# UNITED STATES PATENT AND TRADEMARK OFFICE

APPLICATION NO.	FILING DATE	FIRST NAMED INVENTOR	ATTORNEY DOCKET NO.	CONFIRMATION NO.
10/586,495	08/14/2006	Paolo Cerasoli	GRT/4865-90	4192

<b>Office Action Summary</b>	<b>Application No.</b> 10/586,495	<b>Applicant(s)</b> CERASOLI, PAOLO	
	<b>Examiner</b> QUYNH-NHU H. VU	<b>Art Unit</b> 3763

## **DETAILED ACTION**

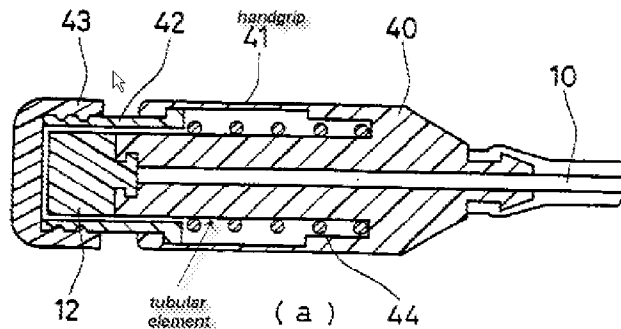
It would have been obvious at the time the invention was made to a person having ordinary skill in the art to modify the device of Littmann in view of Diaz with a connector (as a syringe with spring), as taught by Diaz, in order to compress or place under tension to act as a source of potential energy for driving the syringe piston portion, while in the unloaded position, the syringe has released its potential energy and has driven the piston through the barrel.

As noted that, The combination between the device of Littmann and Diaz will bring the result such as: when the syringe of Diaz inserted into the connection at interconnection 28-31 (Fig. 1-4), 101, 102, 204 (Fig. 5) of Littmann, from there, the charging handgrip, the sleeve and spring of Diaz being arranged so as to bring the end portion of tubular element of Diaz closer to one of the receiving and releasing housings of Littmann by pushing element 52, then the spring 30 compressed (see Fig. 3 of Diaz).
